# Poortjies Wind Energy Facility and associated infrastructure, Northern Cape Province

Motivation for amendment of Environmental Authorisation

DFFE Ref.: 14/12/16/3/3/2/681/1

August 2021

**Figure 2.2:** Poortjies Split EIA layout overlain onto the identified sensitivities (2021) showing turbine positions, BESS and associated infrastructures (A3 Map included in Appendix I).

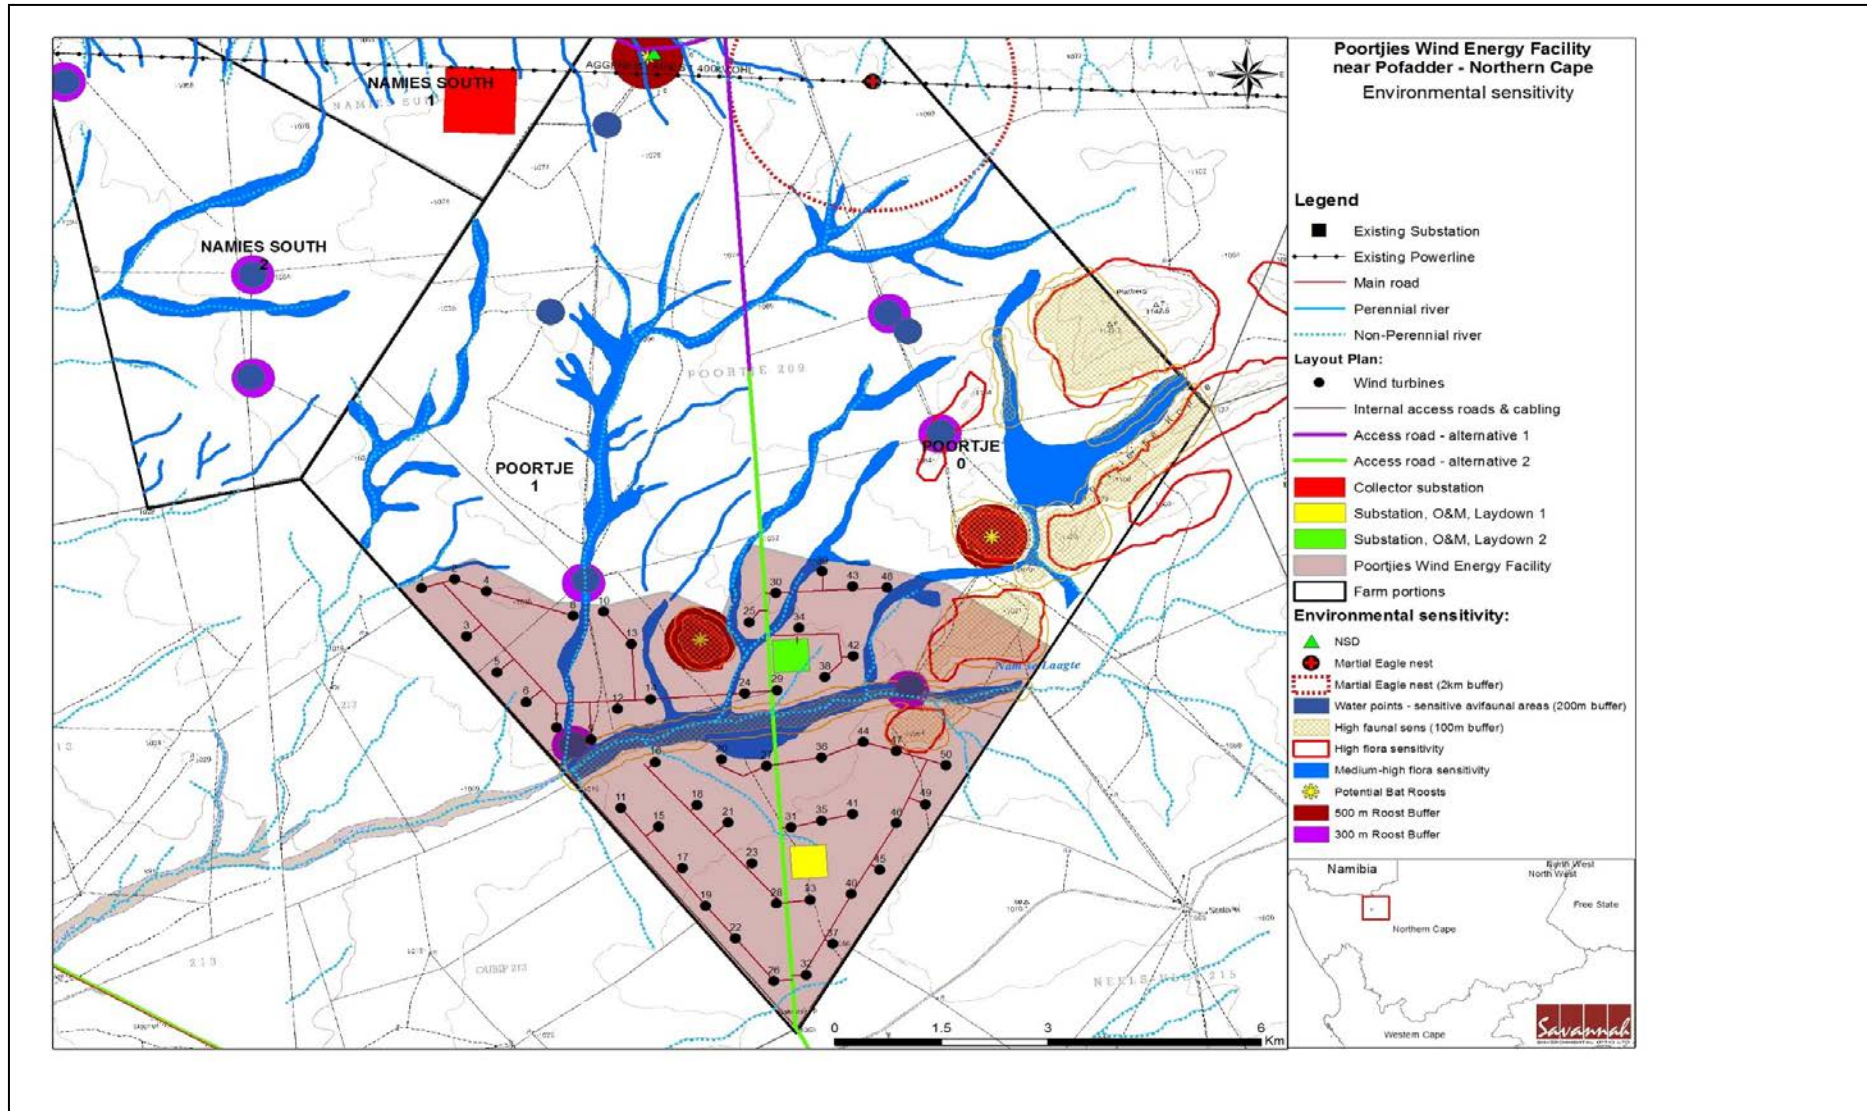
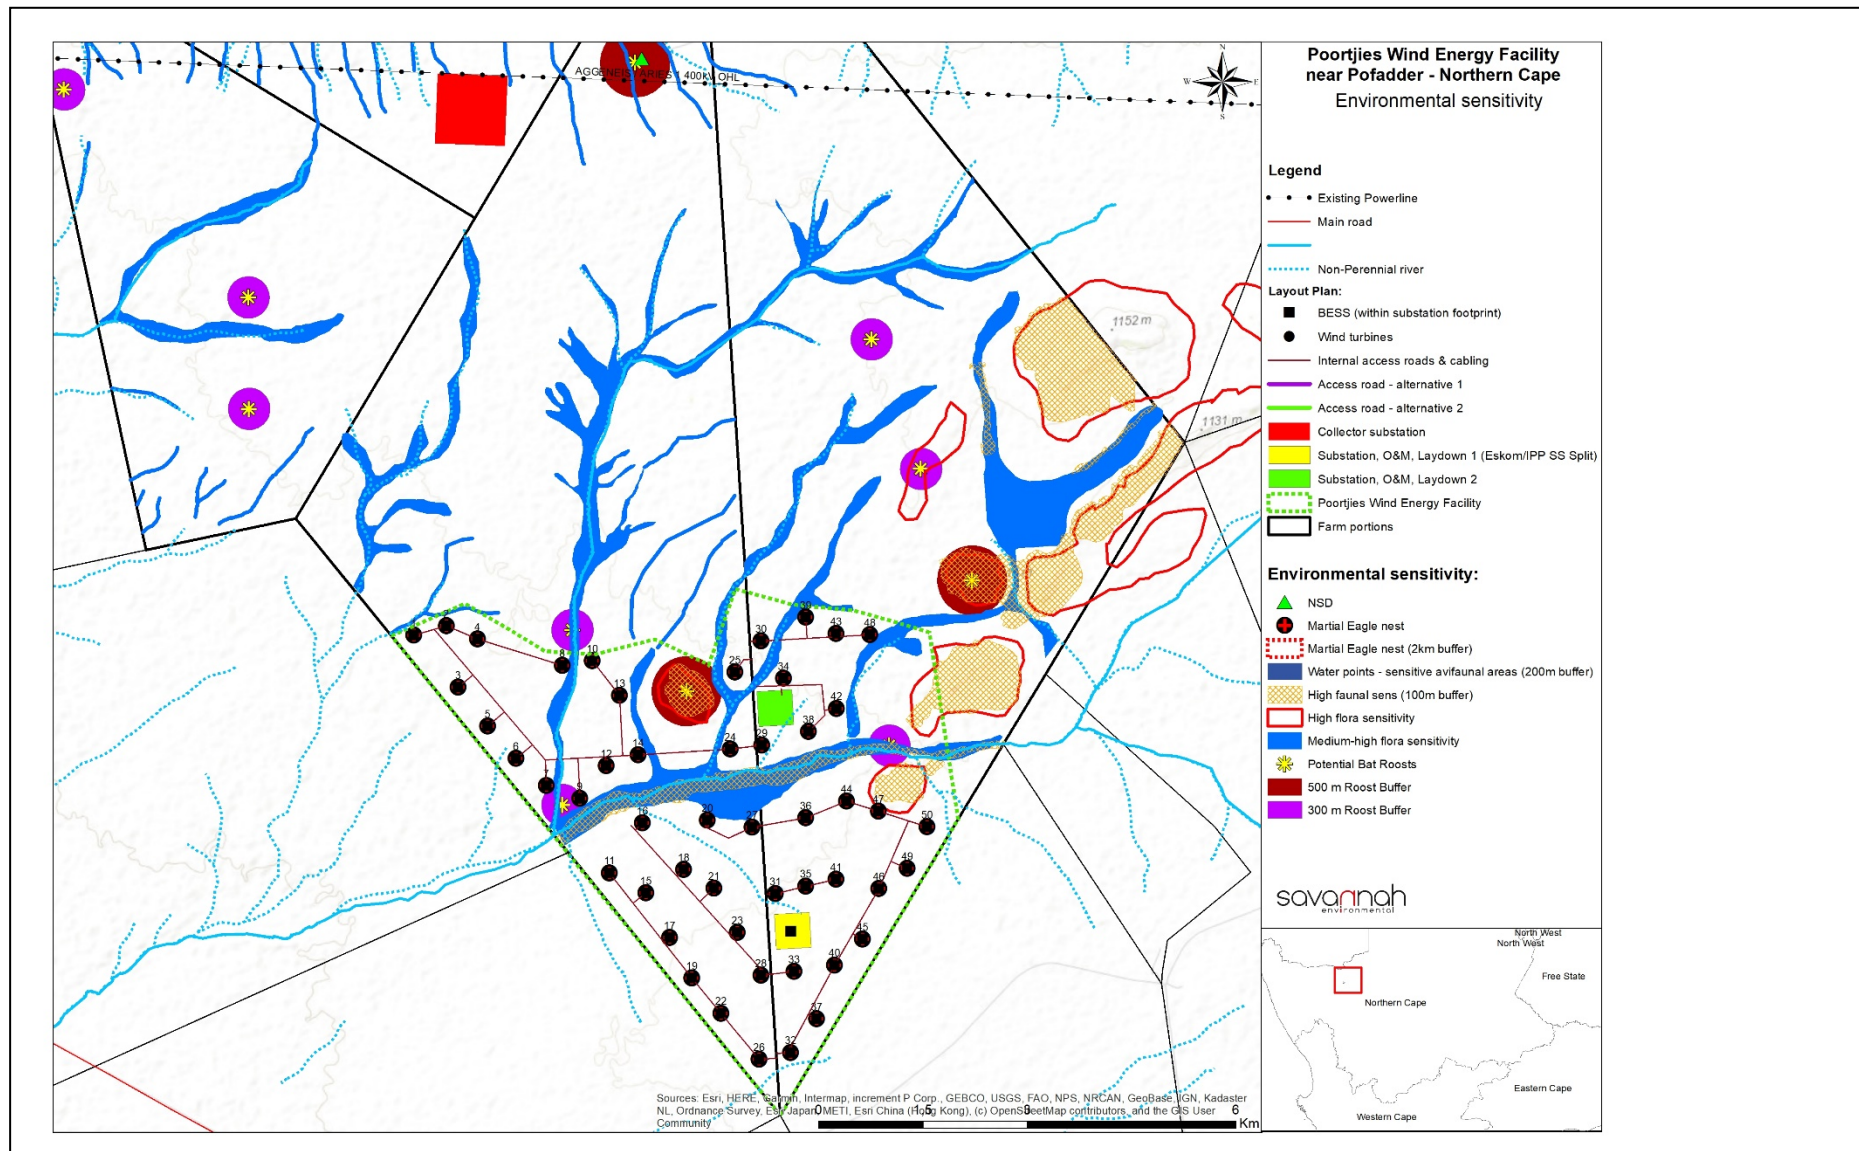
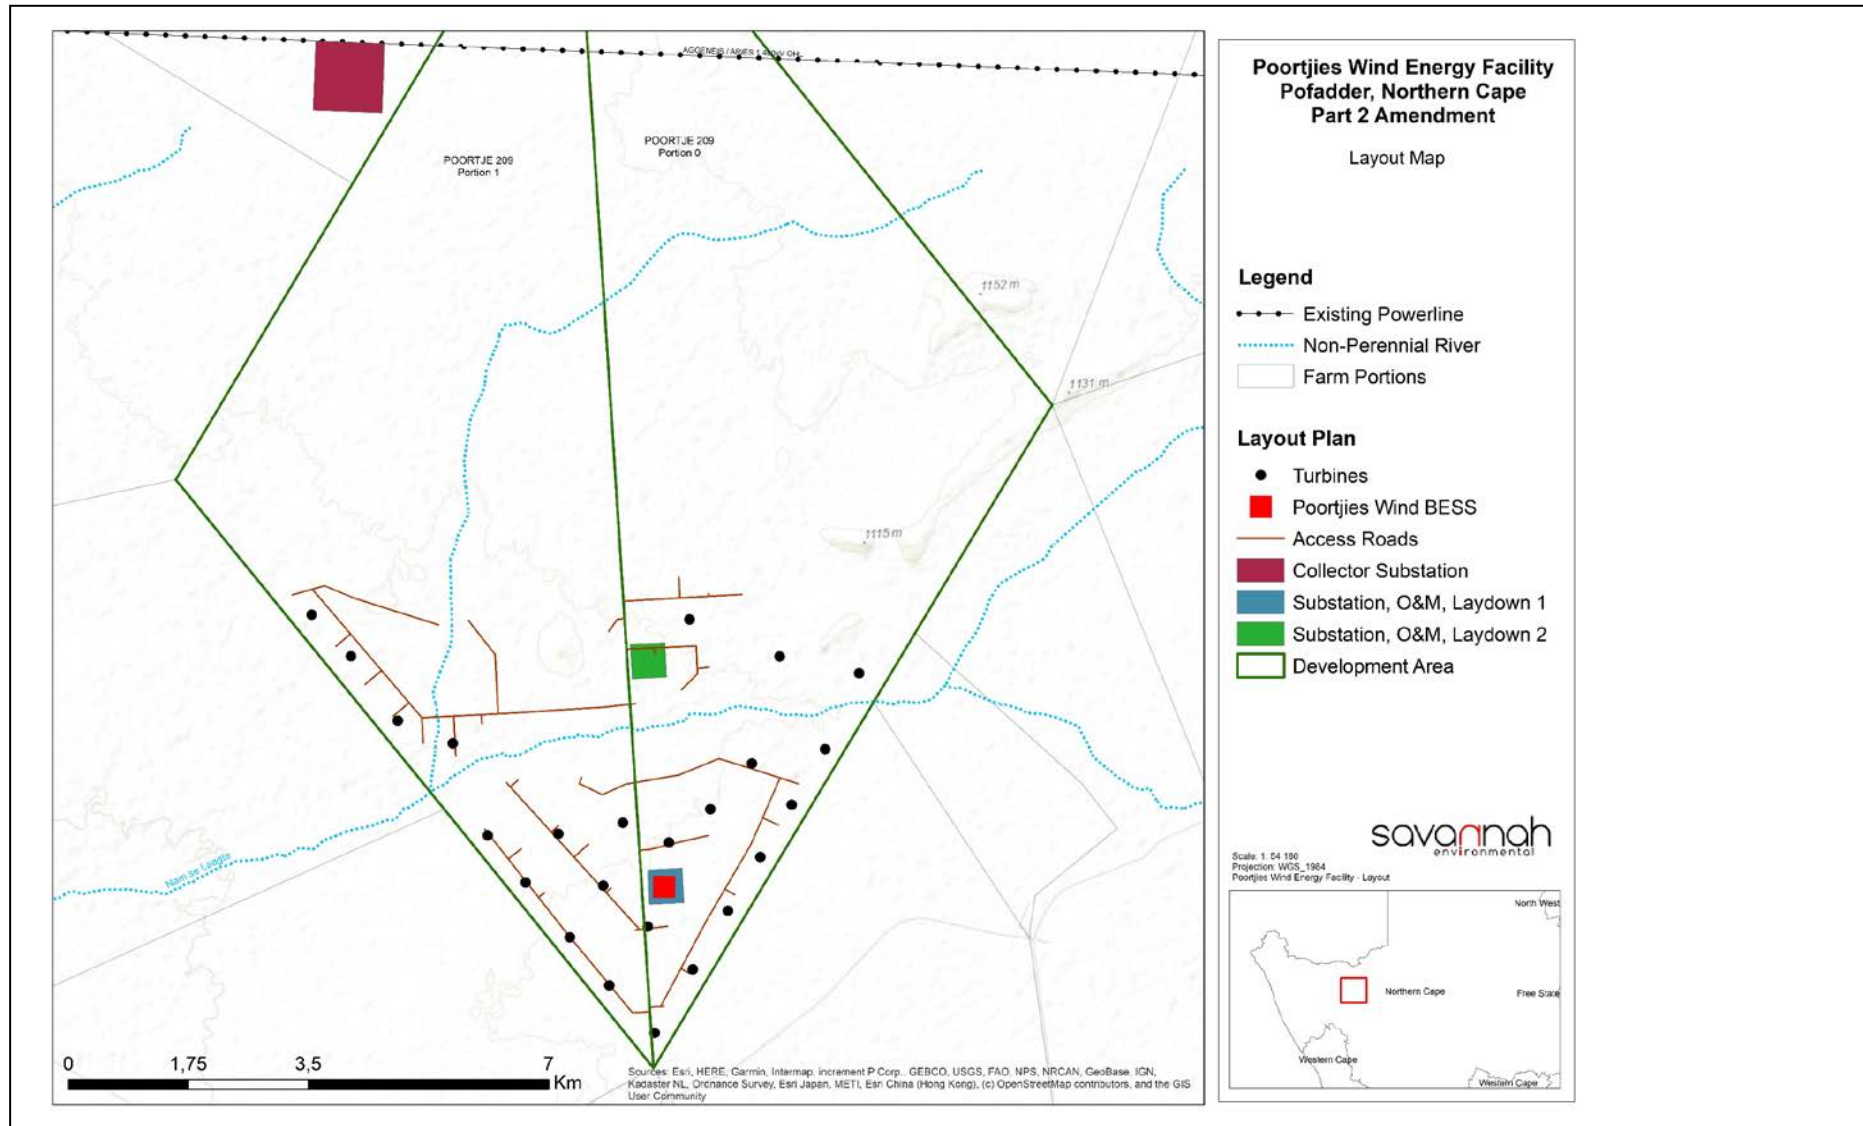
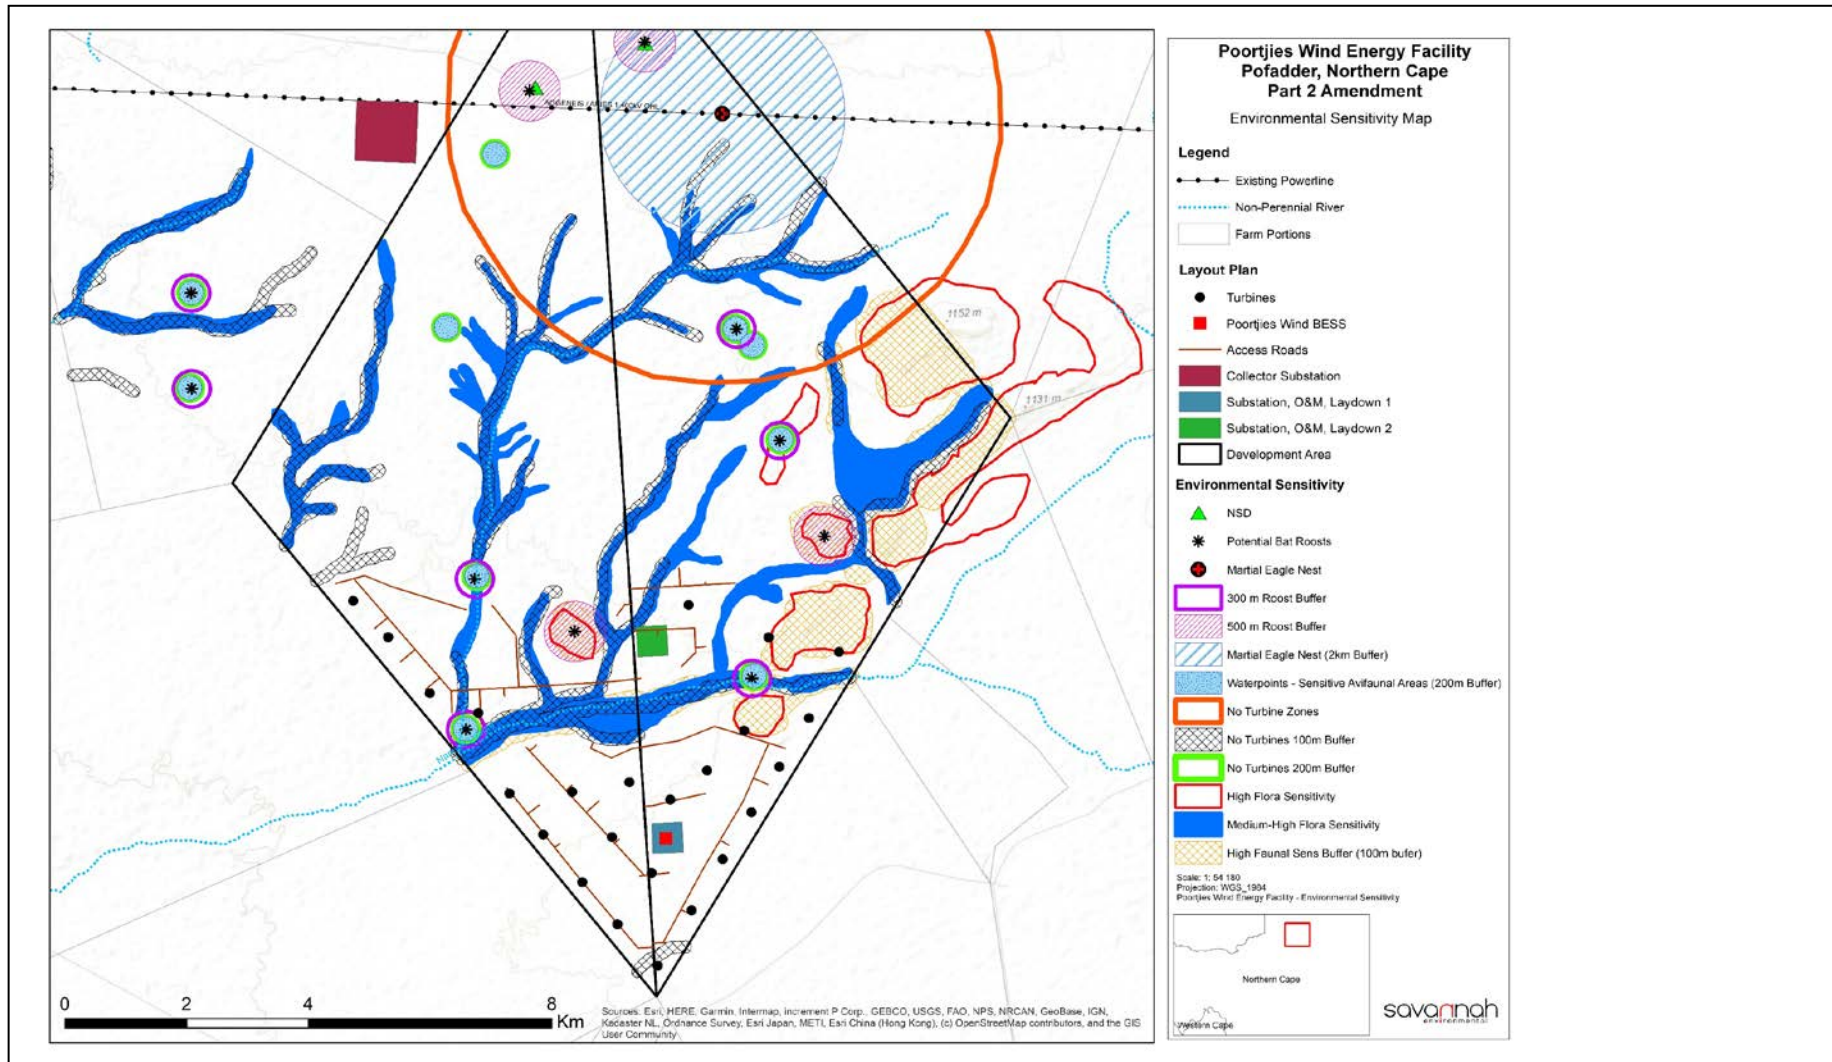
The number of wind turbines are proposed to be decreased from the currently authorised 50 turbines, to 24 turbines. It is therefore requested that the project description in the EA be amended to include the revised number of turbines.

The combined sensitivity map as submitted in the Final EIA Report (2014) is provided in Figure 2.1 and the combined sensitivity map as submitted in the Split EIA Report (2021) is provided in Figure 2.2. The proposed amended layout showing 24 turbines is provided in Figure 2.3 and its associated combined sensitivity in Figure 2.4.

layout. This layout is therefore submitted as part of the amendment to reflect 24 revised turbine positions for the proposed facility.

Figure 5.1: Comparative Viewshed Analysis for Poortjies Wind Farm

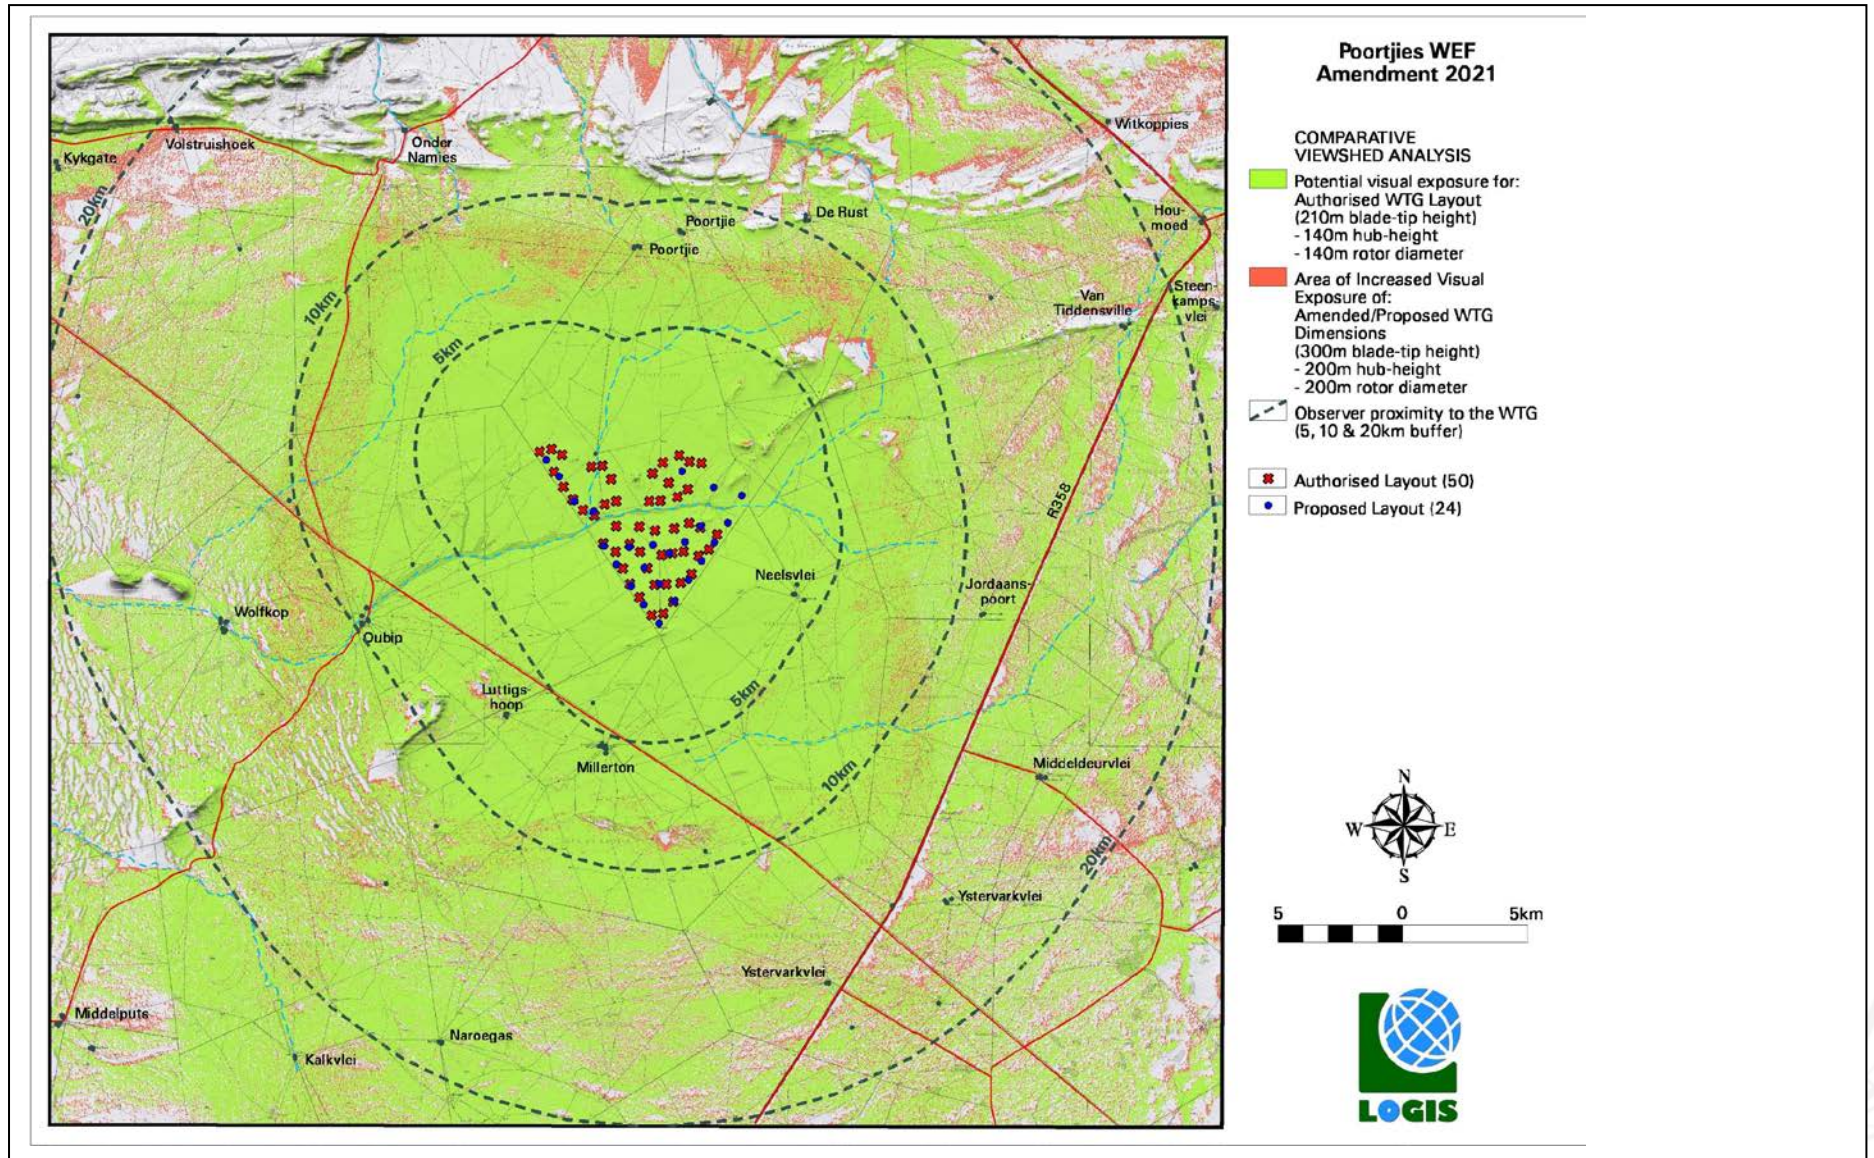
A viewshed analysis was undertaken (**Figure 5.1**) from each of the authorised wind turbine positions (50 in total) at an offset of 210m (maximum tip height) above ground level. The result of this analysis represents the potential total visual exposure of the original and authorised turbine dimensions (indicated in green on **Figure 5.1**). The viewshed analysis was repeated at an offset of 300m to indicate the visual exposure (shown in red) of the increased turbine dimensions (24 in total) proposed as part of the amendment. The results of the viewshed analyses are displayed on **Figure 5.1** overleaf.

The analysis indicated that with the proposed amendments, approximately 30% increase in turbine dimensions, would have a relatively small influence on the overall visual exposure of the wind farm, due to the already tall turbine structures previously authorised and the predominantly flat topography of the surrounding landscape. The surface area (within the study area) of the original turbine exposure is 1,264km<sup>2</sup>, compared to the 1,467km<sup>2</sup> of the increased dimensions of the wind turbine exposure. This is an increase of 203km<sup>2</sup>, or alternatively, an increase of 16% in the potential visual exposure.

In spite of the increase in the turbine dimensions it is expected that the wind turbine structures, both the original dimensions and the proposed increased dimensions would be equally visible and noticeable from both the roads and homesteads identified above. This signifies a negligible change to the potential visual impact with the implementation of the amended turbine dimensions. Therefore, no impact tables are presented here.
